Re: Comments and Recommendations on the Draft Supplemental
Environmental Impact Statement (SEIS) for the License Renewal of
Nuclear Plants for Turkey Point Nuclear Generating Unit Numbers 3 & 4

The U.S. Department of the Interior (Department) has reviewed the Draft Supplemental Environmental Impact Statement (SEIS) to the Generic Environmental Impact Statement for License Renewal of Nuclear Plants Regarding Subsequent License Renewal for Turkey Point Nuclear Generating Unit Nos. 3 and 4 (EPID No.L-2018-LNE-0001) Docket ID NRC-2018-010.

Turkey Point Nuclear Generating Unit Nos. 3 and 4 – ER 19-0139

Figure 1. Groundwater tritium concentrations in the Turkey Point Cooling Canal System, adjacent areas, and within the Card Sound region of Biscayne Bay.

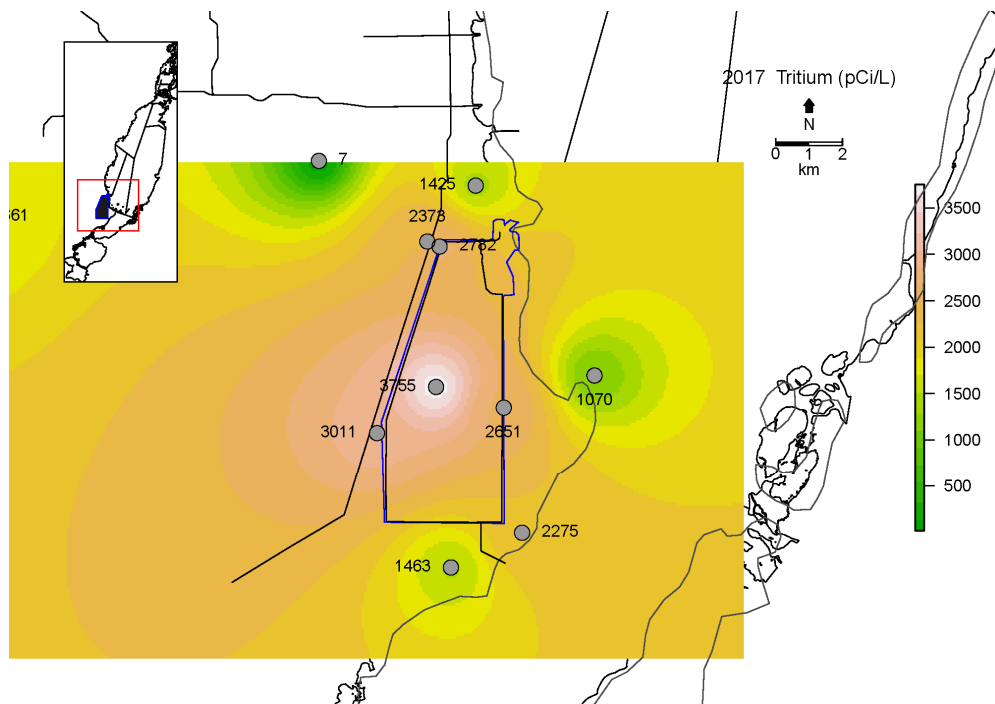
FPL, through guidance by the Florida Department of Environmental Protection (FDEP), uses the presence of tritium to trace water movement from the CCS into surrounding areas. As tritium in natural conditions is expected to be lower than 20 pCi L⁻¹, concentrations in sampled waters indicate higher levels that are attributable to the CCS. Groundwater sampled in a series of wells within the CCS and Card Sound show that concentrations are exceptionally higher than the background level (Figure 1). These extremely elevated levels of tritium are a clear indicator of CCS water infiltration into the bay and ultimately a signal of the adverse impacts the bay is experiencing as a result of operations of the CCS. This is further evident in the elevated groundwater samples concentrations for Total Nitrogen (TN) in Figure 2 and Total Phosphorus (TP) in Figure 3.

Figure 4. Total nitrogen in Turkey Point Cool Canal System and adjacent surface water in Card Sound region of Biscayne Bay.

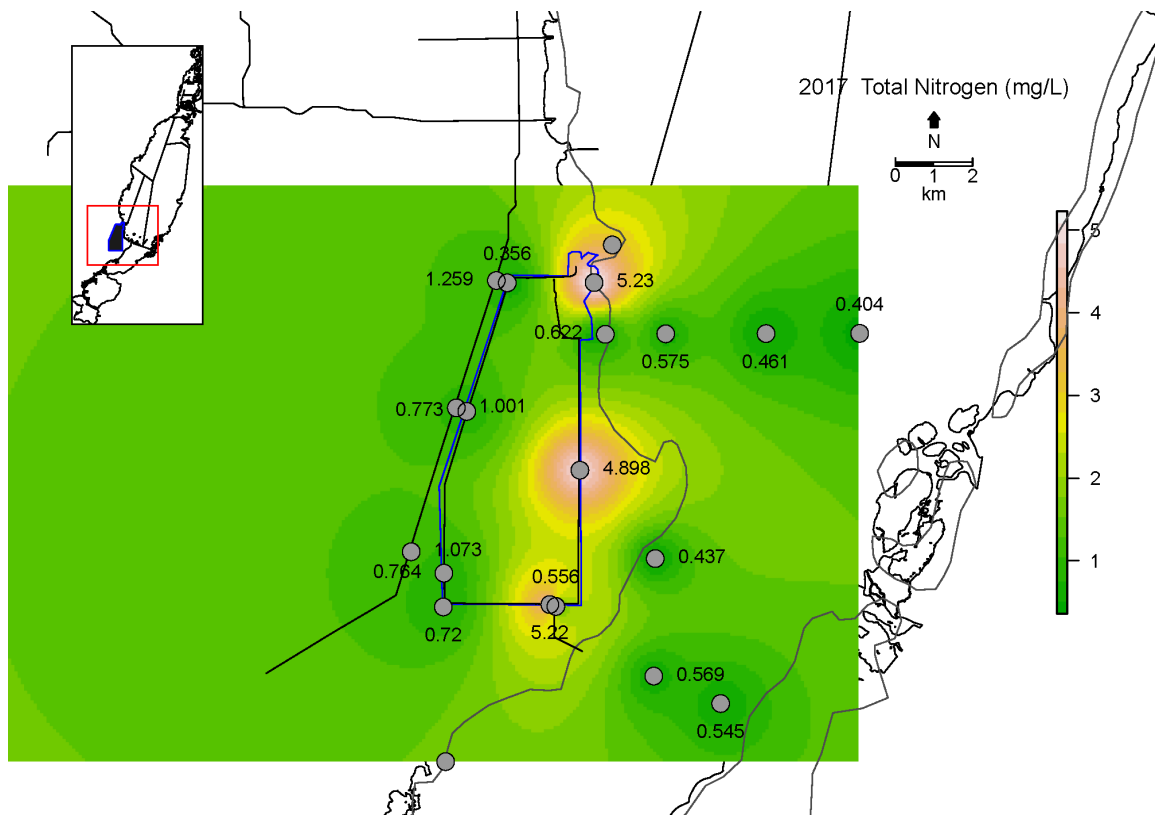
3) Water Quality Impacts Biscayne Bay – The numeric nutrient criteria, established by the Florida Department of Environmental Protection, does not appear to be taken into account when scoring the impacts to surface water resources in Biscayne Bay in the EIS. Review of these nutrient criteria over the past few years shows that Total Nitrogen (TN) and Chlorophyll-a (Chl-a) have exceeded these criteria. Calendar year 2017 is a prime example of these conditions. Monitoring for the Turkey Point Cooling Canal System (CCS), shows that TN concentrations in the surrounding canals were greater than the TN numeric criterion (0.33 mg L^{-1}) by as much as three times (Figures 4 and 5). Similarly, sample locations established as transects from the east side of the CCS within Card Sound, all show TN concentrations that exceed the criterion with the highest values found in the locations closest to the CCS (Figure 4). Transects established from the east boundary of the CCS into Card Sound also show that Chl-a concentrations exceed the criterion (Figures 6 and 7). Given these elevated bay conditions appear to be linked via groundwater transport (see comments in the groundwater section) to the CCS, the rating established in Table 2-2 appears to underestimate the existing impacts of the CCS on Card Sound and the score, based on existing data, should be elevated to “Large.”
